RE: REVISED DRAINAGE PLAN FOR SUNWEST BANK DRIVE-UP FACILITY
(J-14/D24) ENGINEER'S STAMP DATED MARCH 24, 1986

SUNWEST BANK DRIVE-UP FACILITY

GRADING & DRAINAGE PLAN

RE: DRAINAGE PLAN FOR SUNWEST BANK DRIVE-UP FACILITY
RECEIVED MARCH 10, 1986 (J-14/D24)

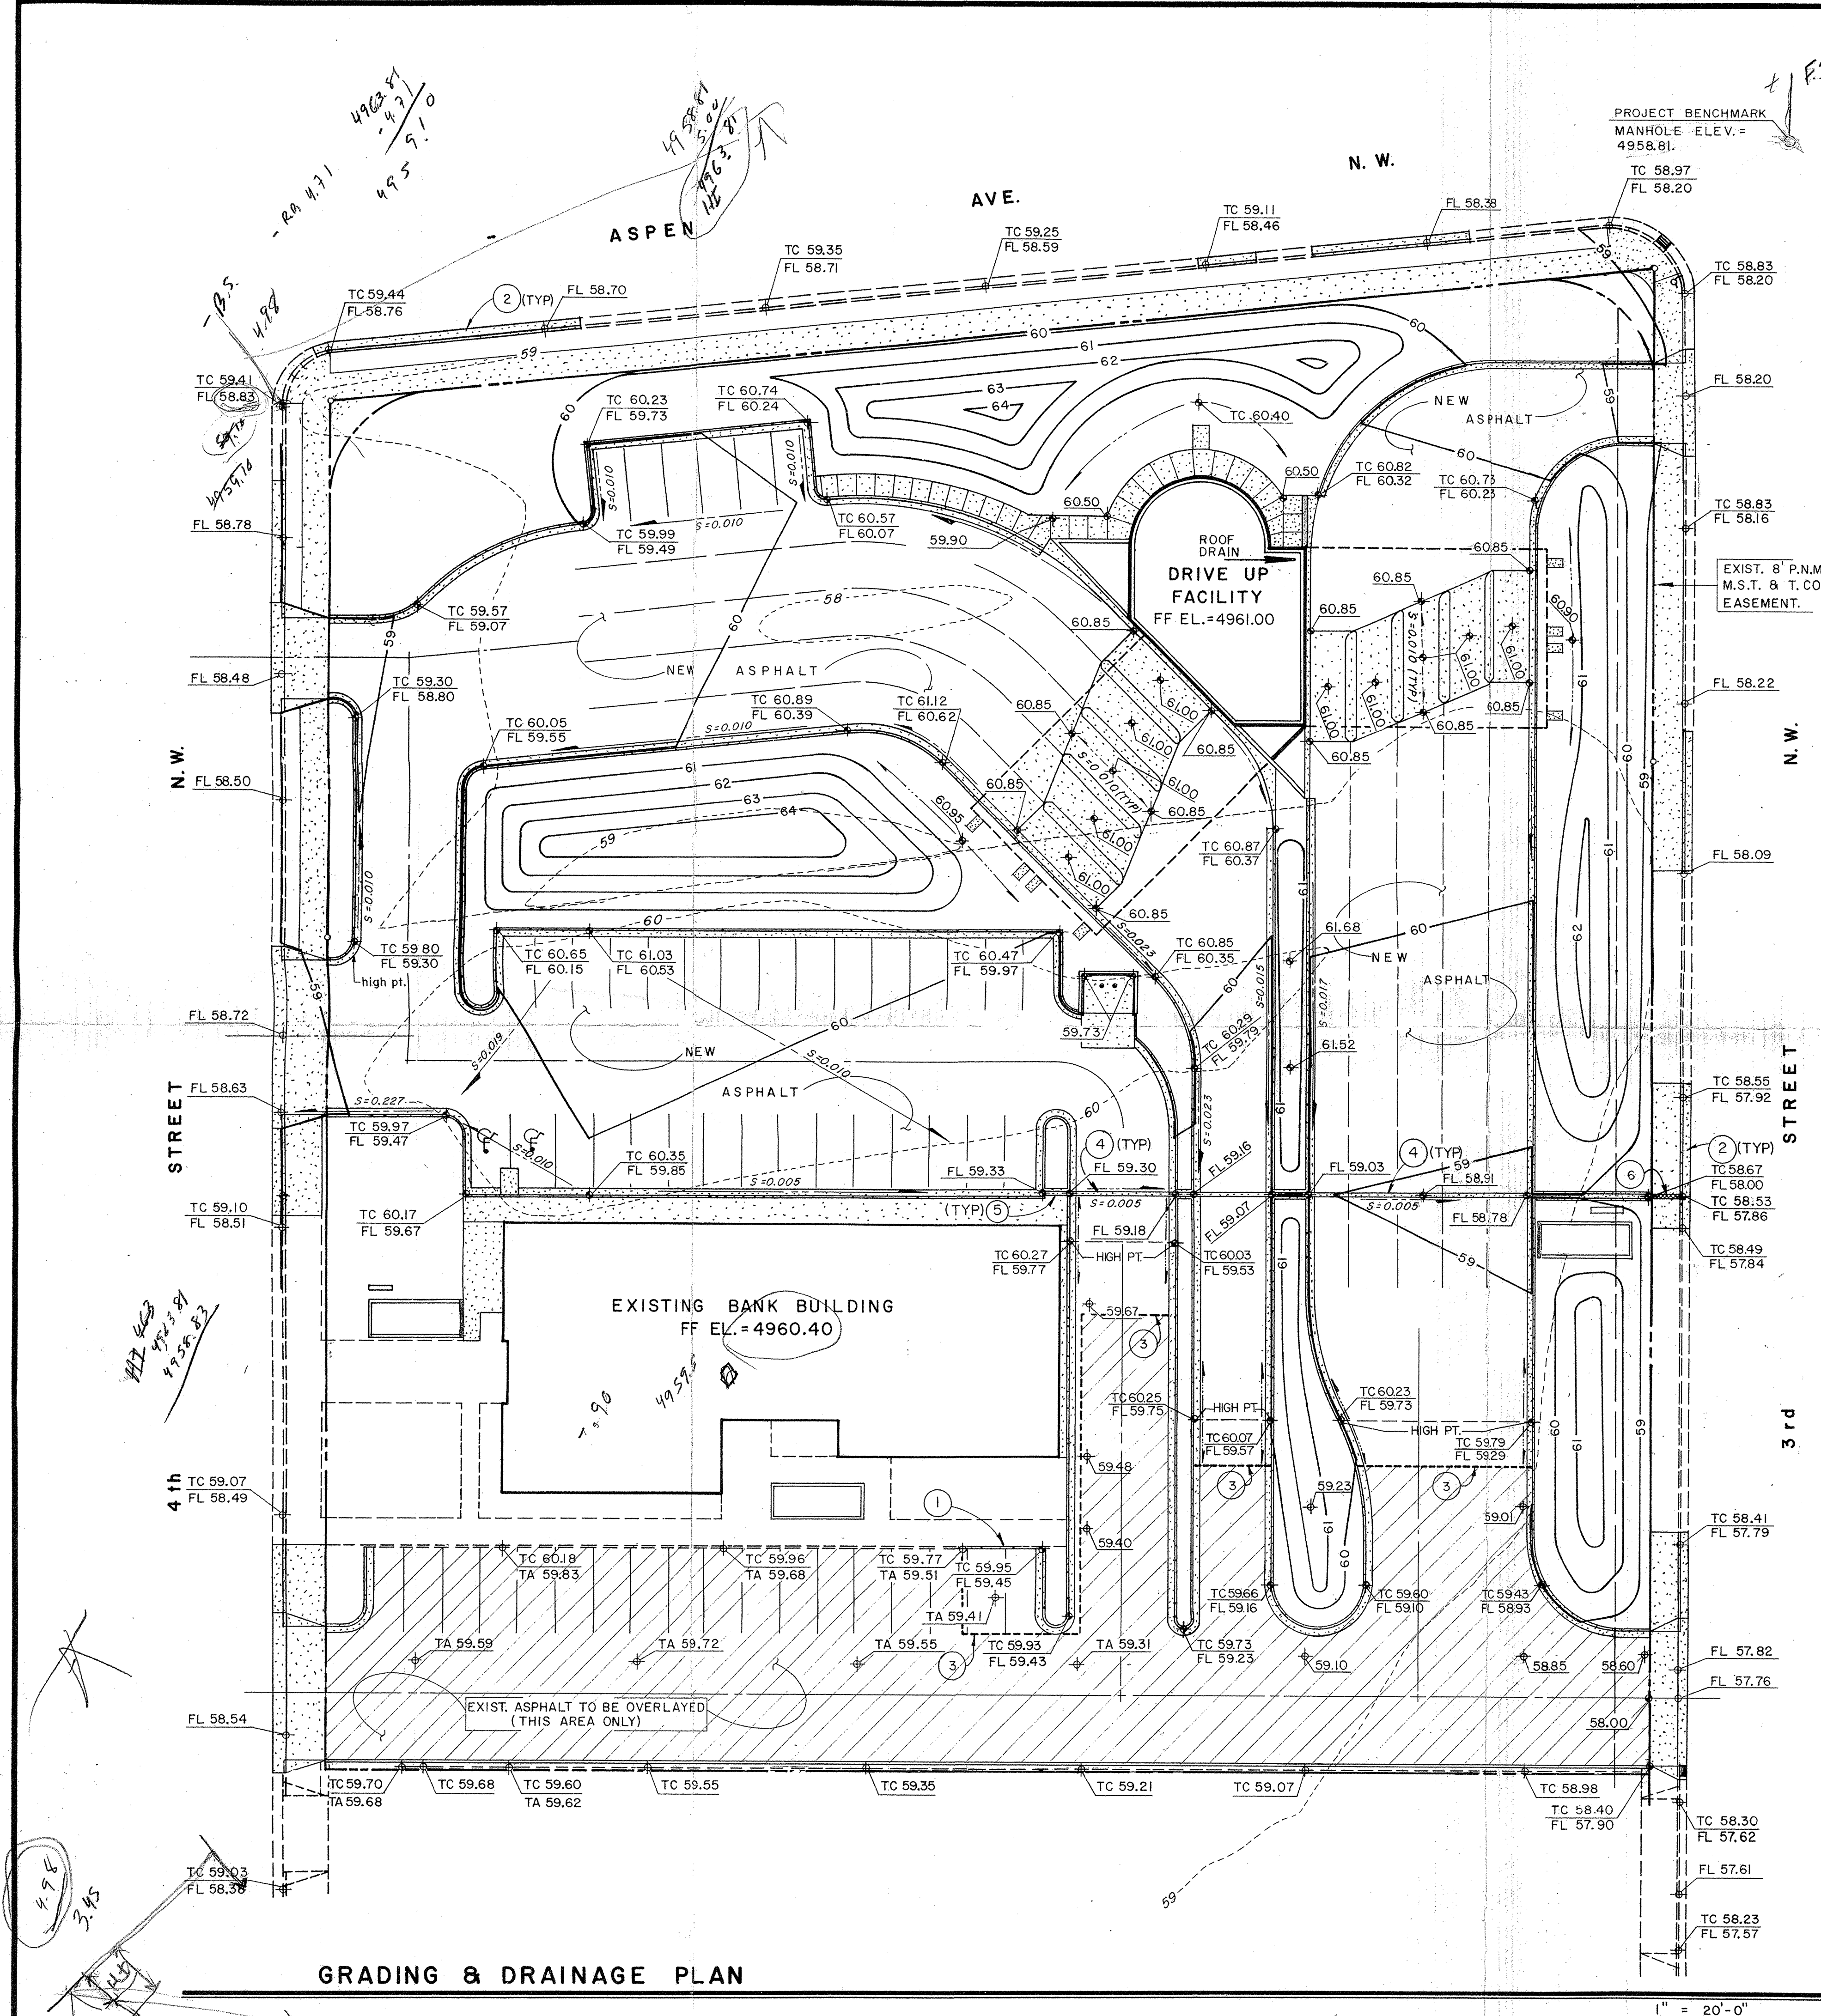
1. New information sheet with resubmittal designation.
2. Engineer's stamp with revision date and signature.
3. Drainage easement or covenant required for cross-lot line drainage.
4. Field inspection has revealed that the portion within Tract A is completely undeveloped at this time (please adjust calculation to indicate these).
5. You will also need to use the new criteria found within the "Notice of Emergency Rule" signed by the Mayor on January 14, 1986, to recompute your developed undeveloped flow rates.

6. You must also indicate that the habitable finish floor elevation is the floodplain elevation, and that the engineer must certify the finish floor after completion.
7. Based on your new calculations, you may need to analyze downstream capacity.

- ✓ 1. New information sheet is enclosed with resubmittal.
- ✓ 2. Engineer's stamp with revision date and signature is on revised plan.
- ✓ 3. The total site is currently being platted into one lot. We realize you will not sign off for building permit approval until the platting has been approved, but would like to get drainage plan approval with the contingency of plat approval.
- ✓ 4. The calculations enclosed will reflect runoff before demolition of the motel located within Tract A.
- ✓ 5. Calculations have been revised using the new criteria within the "Notice of Emergency Rule".
- ✓ 6. A note has been added to the plan indicating the habitable finish floor elevation and the requirement of having the finish floor certified by the engineer prior to C.O.
7. Downstream capacity has been analyzed using revised calculations.
